© 2016 Mazda Motor of America, Inc.

Subject: AIR TEMPERATURE WILL NOT CHANGE	Bulletin No: 07-003/16
	Last Issued: 09/13/2016

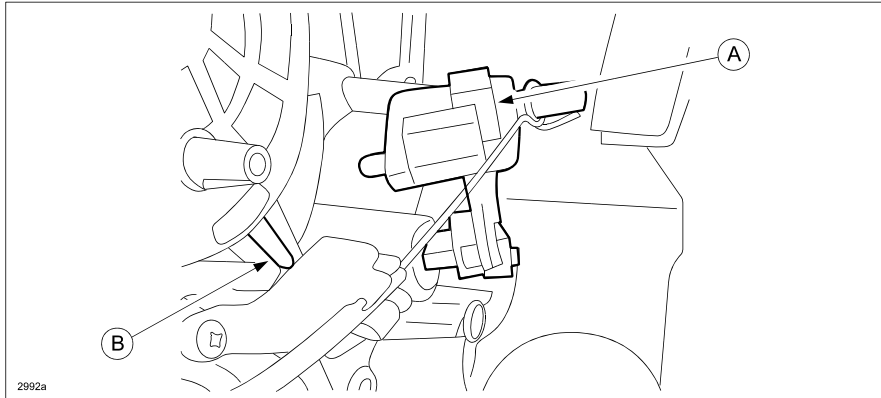
Some customers may complain that the air temperature from the air conditioner will not change with the air temperature control knob, and may be accompanied by some rattle noise from behind the dash board. This concern may be caused by the temperature control link being pulled out of the HVAC housing. To correct the problem, the temperature control link has been modified.

1. Verify customer concern.
2. Refer to the instructions on MS3 online or the Workshop Manual (section 07-40 CLIMATE CONTROL UNIT REMOVAL/INSTALLATION [MANUAL AIR CONDITIONER]) and check that the MIX LINK (Air mix link/Temperature control link) (A) is properly connected to the MIX DOOR CRANK (B) and works while rotating the temperature control knob.

3. **Japan built vehicles:**

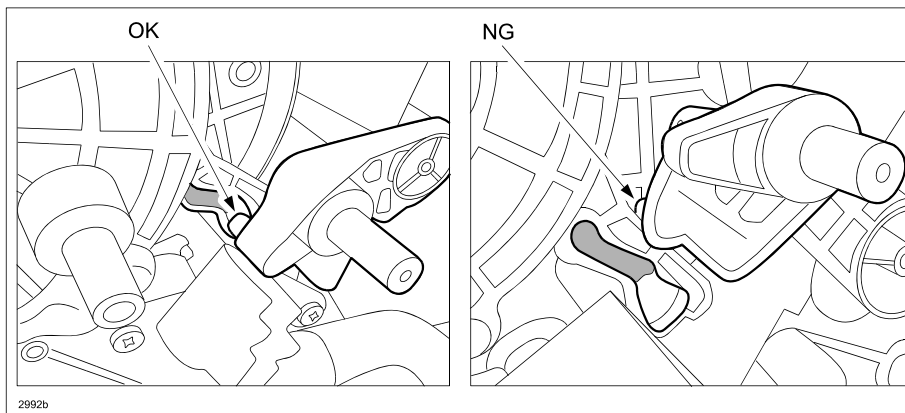
Replace the MIX LINK with a modified one. Refer to MS3 online (A/C UNIT DISASSEMBLY/ASSEMBLY). Make sure that the MIX LINK is fitted in the groove of the MIX DOOR CRANK and will not come out with movement.
